1055 CANADA PLACE (COMPLETE AFTER PRELIMINARY APPLICATION)
DE408490 - ZONE CD-1

DEVELOPMENT PERMIT STAFF COMMITTEE MEMBERS

DEVELOPMENT PERMIT STAFF COMMITTEE RECOMMENDATION: APPROVE

Fig. 6 - Model showing proposed Thurlow Plaza (from north, looking south)

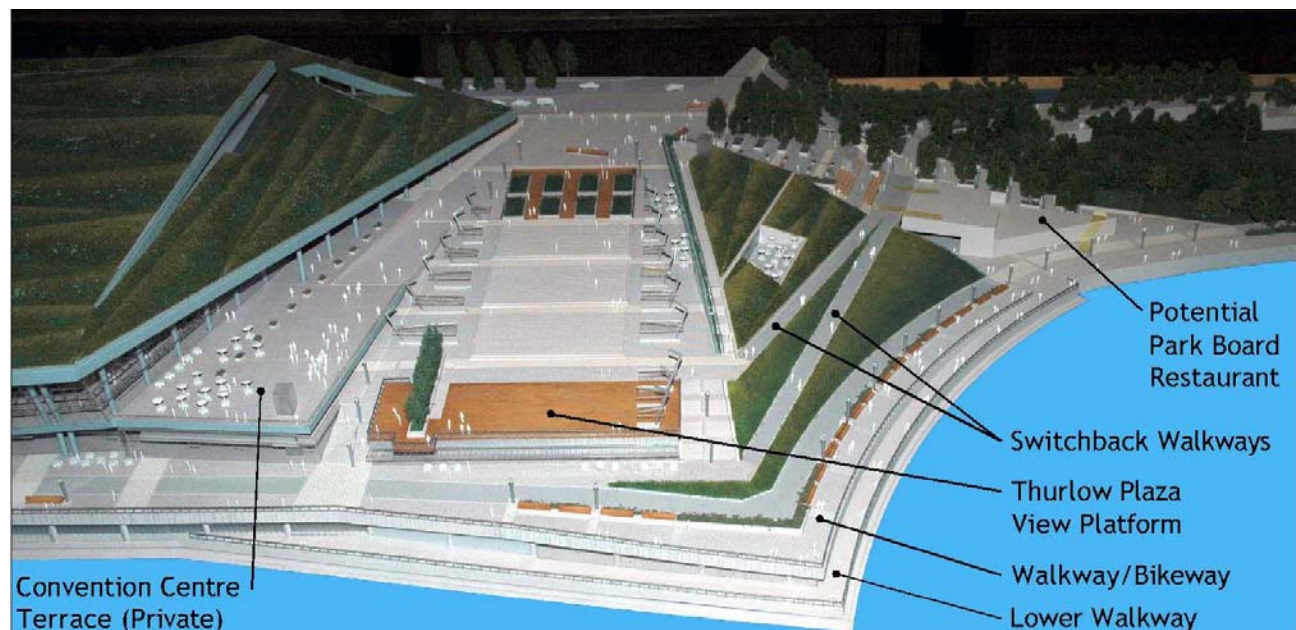
A number of detailed design refinements are described in recommended condition 1.5: Notes to Applicant a) - g) (refer also to Appendix K; Open Space Images). Specifically, the southerly portion of the Plaza (Figs. 7 & 8) lacks a sense of arrival, and the visual interest of its surface treatment needs to be improved. This "forecourt" of Thurlow Plaza needs a strong identity, animated and informed possibly by the extension or referencing of the "Grand Stairs" axis, the "prow" of the plaza restaurant roof, the north/south axis of the central open space, the angular entry of the convention centre and the Canada Place street frontage. For the raised planter area to the north of the plaza "forecourt" (Fig. 9), a revised planter geometry should be incorporated that creates a defined space(s) with integrated seating. Reallocating some seating to take specific advantage of strategic water-viewing locations (i.e. the north raised viewing platform and switchback walkways) is also recommended, as well as maximizing the extent of "storefront" glazing for the retail use along the east edge of the plaza. Staff are also concerned with the proposed 1 m difference in floor level of the plaza restaurant and adjacent plaza (recommended condition 1.7).

Fig. 11 - Model showing Burrard Plaza & east edge of Convention Centre

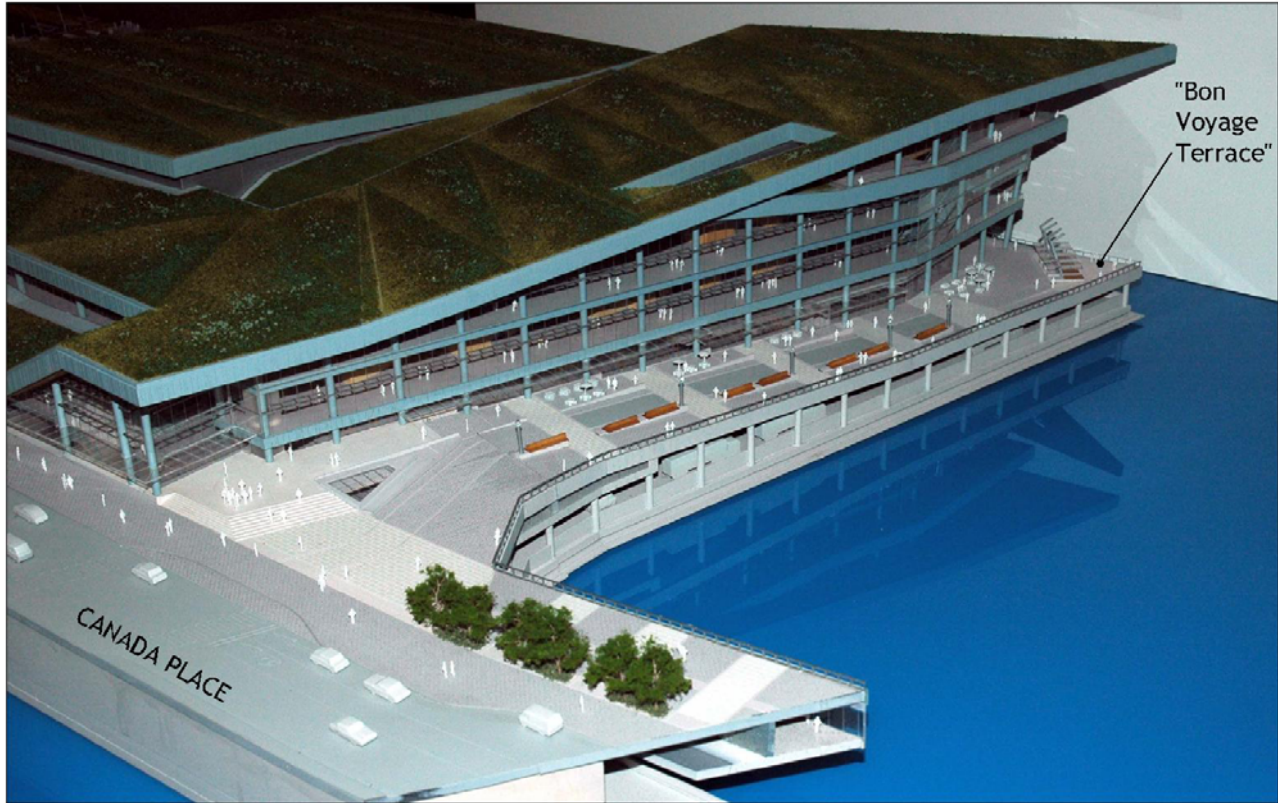
1.19: Council has approved the CHODP text amendment allowing minor intrusions into the Burrard Street-end view. The roof configuration at the southeast corner entrance at Burrard Street has been revised from the previous sloped glass roof extension to provide a generally flat edge expression extending around the corner on Canada Place and partially into the view corridor, which Staff support. The entry facades are fully glazed, extending about 17 m in height, with glazed canopies at the lower pedestrian level. Staff consider this resolution to have satisfied the condition with the one further suggestion to introduce a more dynamic canopy design announcing the main building entrance (recommended condition 1.14: Note to Applicant).

Fig. 12 - Model view of building's north side showing edges of roof and walkway, and loading dock screening

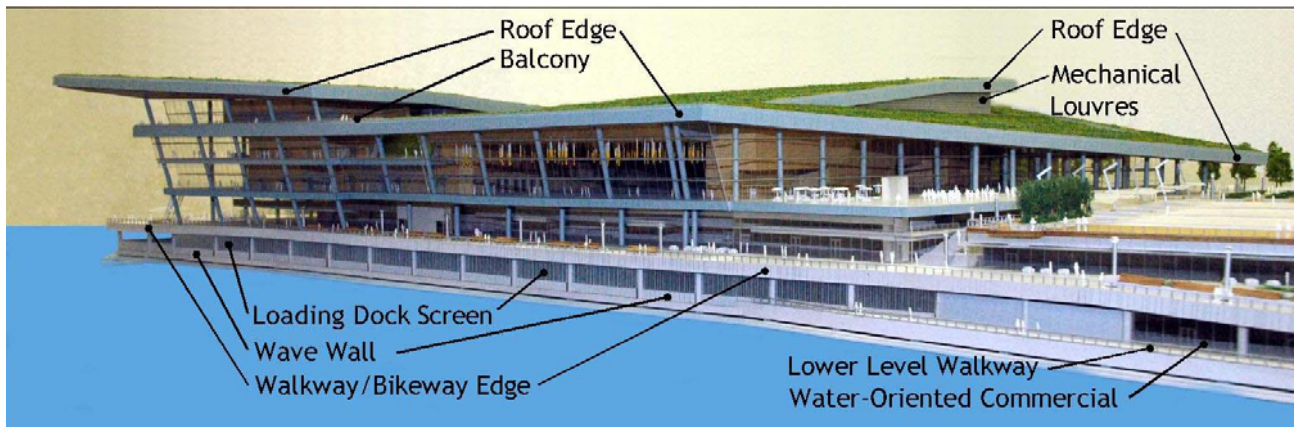
1.18 design development to enhance the proposed screening of the loading docks (pre-cast concrete) on the north, west and east edges to be an integral architectural component of the overall design, introducing more variety, pattern and higher quality materials as well addressing night-time conditions when the docks will be illuminated;

1.18: The screening of the loading docks will be reviewed with staff at a future workshop. The issue of the height of the "wave wall" should be resolved prior to the determination of the extent and detail of the loading dock screening.
